**SUBDIVISION COMMITTEE
METROPOLITAN AREA PLANNING COMMISSION**

STAFF REPORT
(Final Plat)

CASE NUMBER: S/D 92-41 - THREE R's ESTATE ADDITION

LOCATION: North of 69th Street North and west of Hillside

VICINITY MAP:

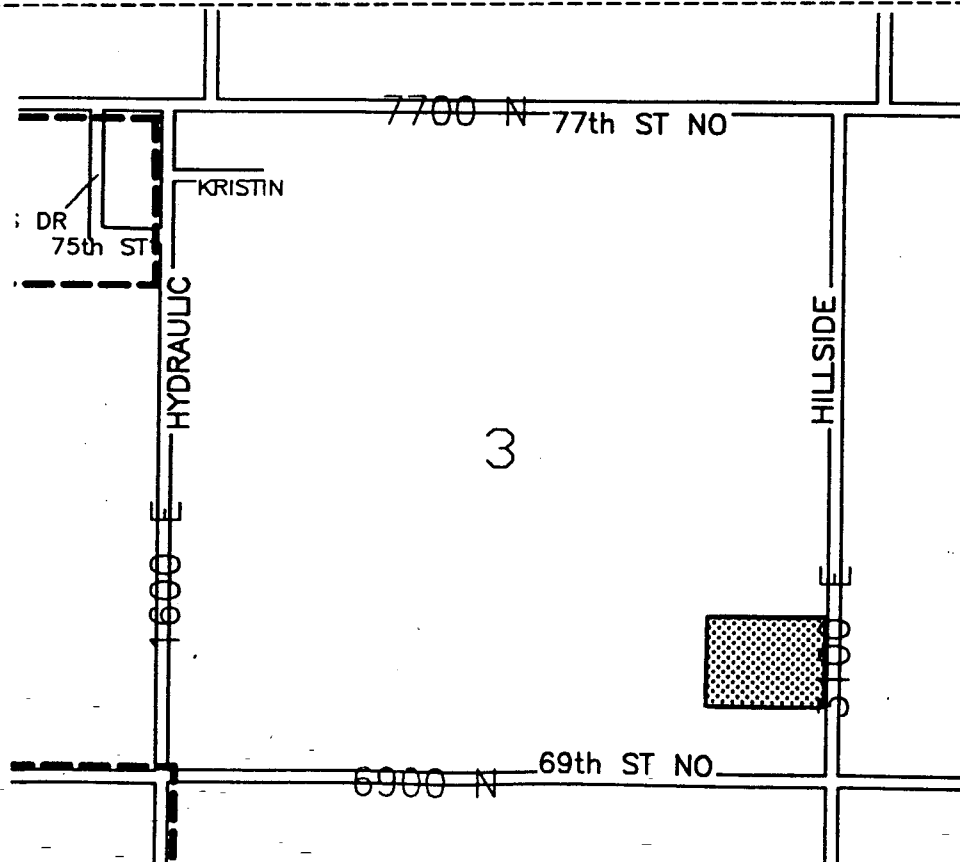
- D. As indicated by the sketch plat, an existing home on this site has been provided access to Hillside by means of a recorded ingress/egress easement. Rather than dedicate and guarantee a public street for the three lots now being platted, the applicant is requesting to use this existing access easement for all three building sites.

In reviewing the aerial photo of this site, a public road along the north line of this site would seem to be a reasonable expectation. However, such road would largely be to the benefit of the property to the north and could be expected to be

dedicated in total when and if that property subdivides. A contingent dedication of right-of-way along this site's north line is an option that could be considered. Planning Staff has also noted that the location of the existing access easement is somewhat of an awkward situation in terms of how it divides the lots and has suggested that if no public street dedication is required along the north property line, that an alternative access easement be considered here. This alternative easement would be created in order to allow for the possible elimination by the property owners of the present easement.
